APPEAL SUMMARY

Appeal ID: 15734

Project Address: 55 NE Grand Ave

LUR or Permit Application No.: 16-112454-REV-02-MT

1 FLOOR PLAN BASEMENT SECTOR 'A' - PLUMBING
P2.10A SCALE: 1/8\"/>

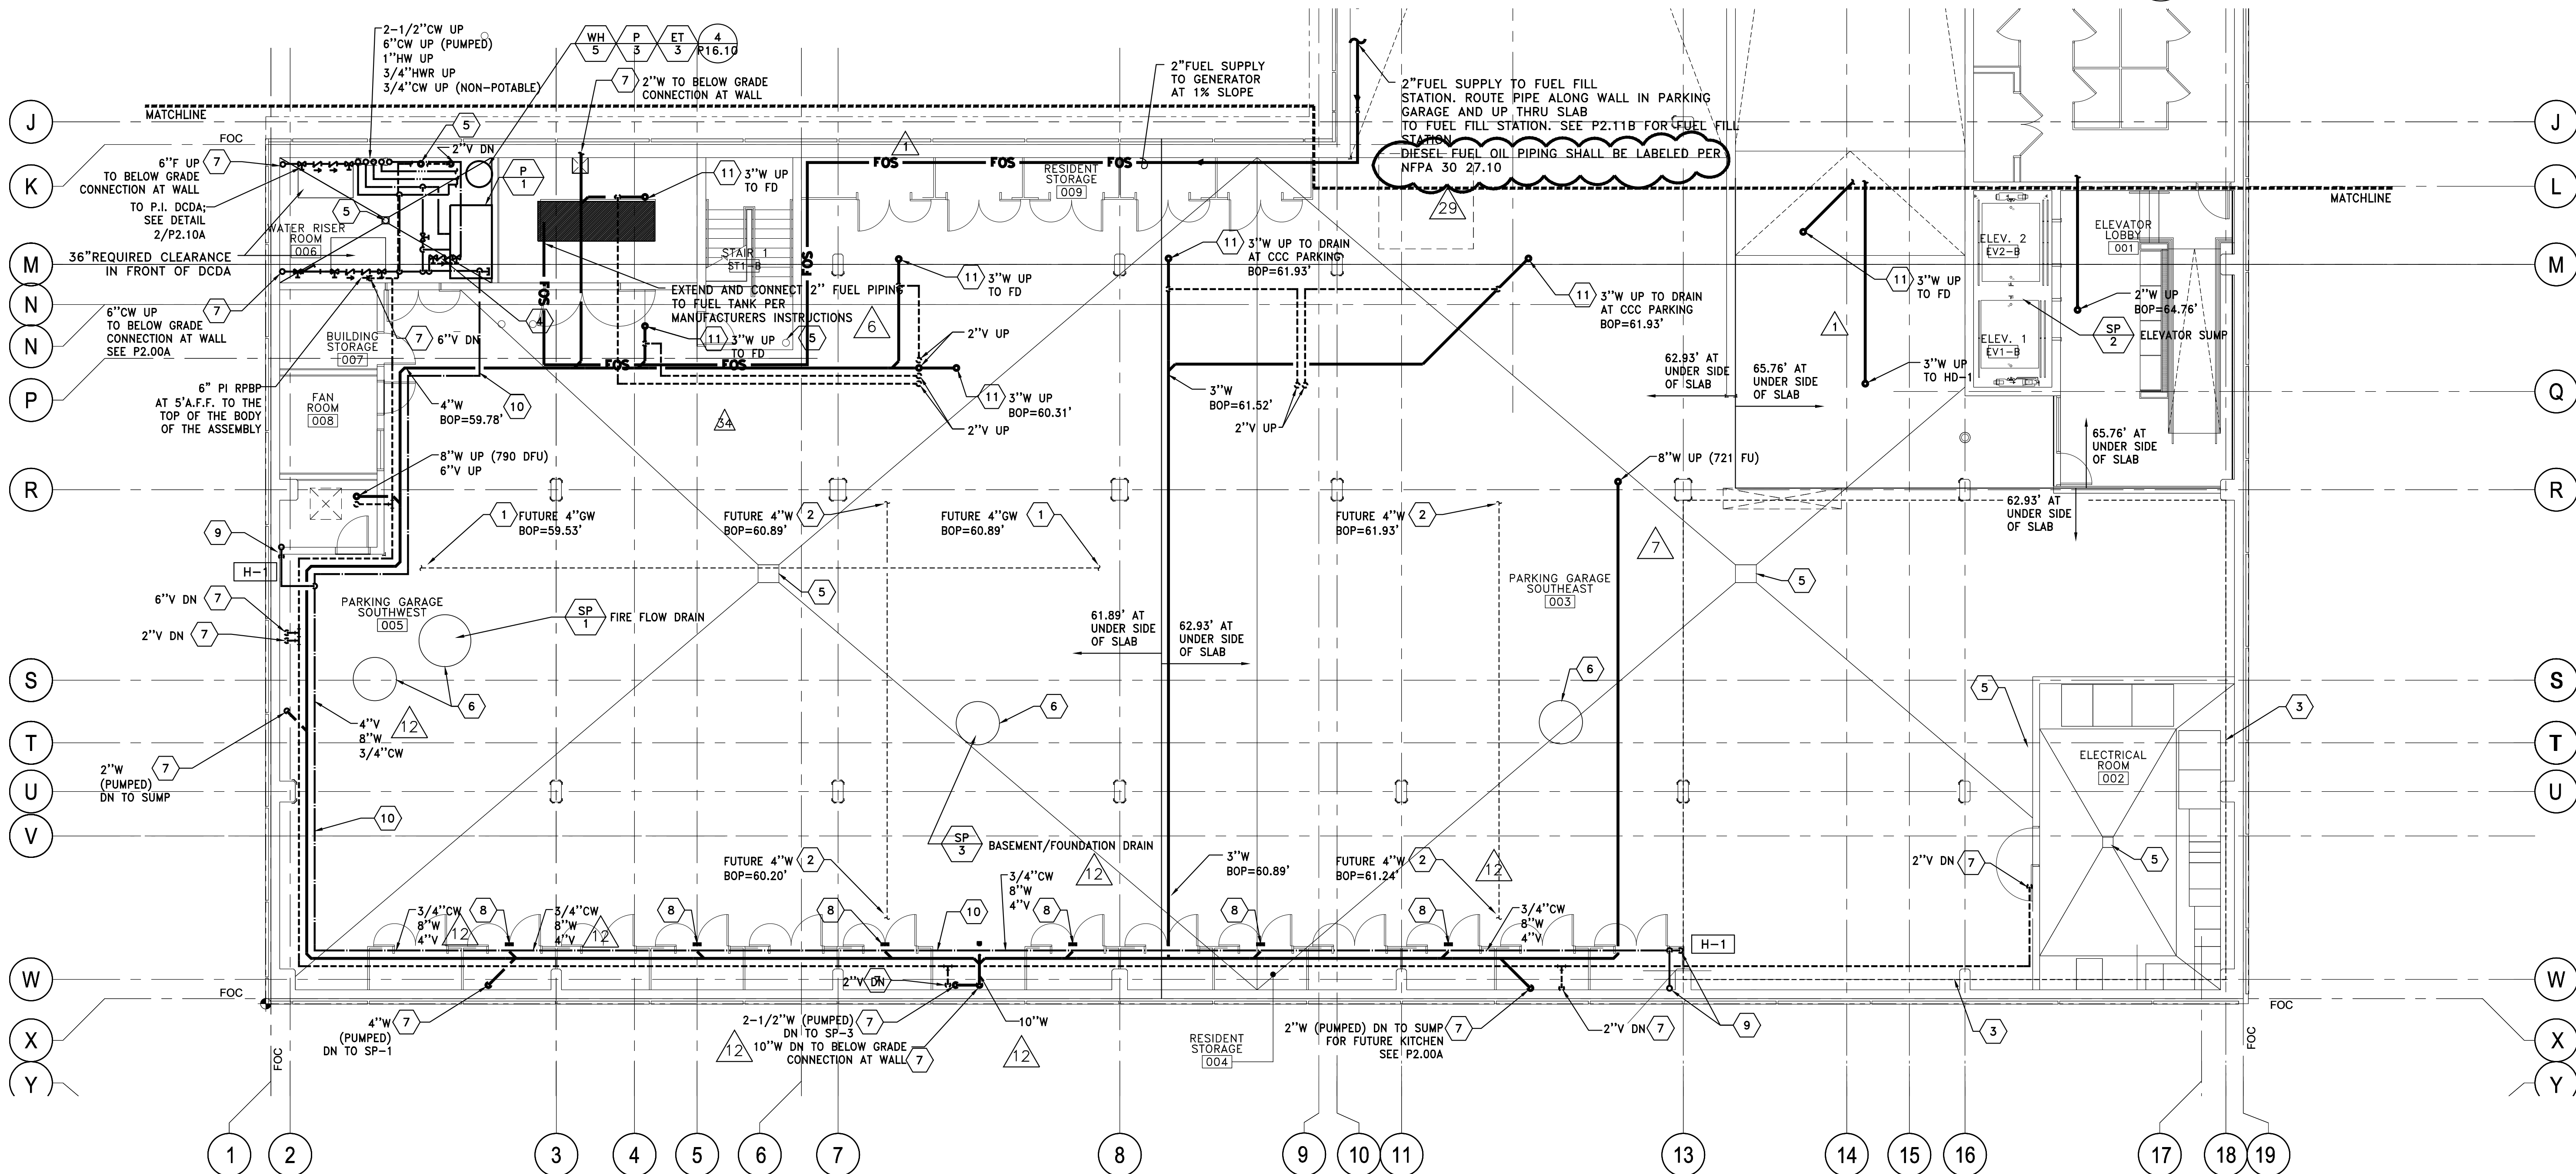
Generator tank remote fill station information and plumbing plans showing the piping for the fuel fill are attached to the appeal for reference of needed.
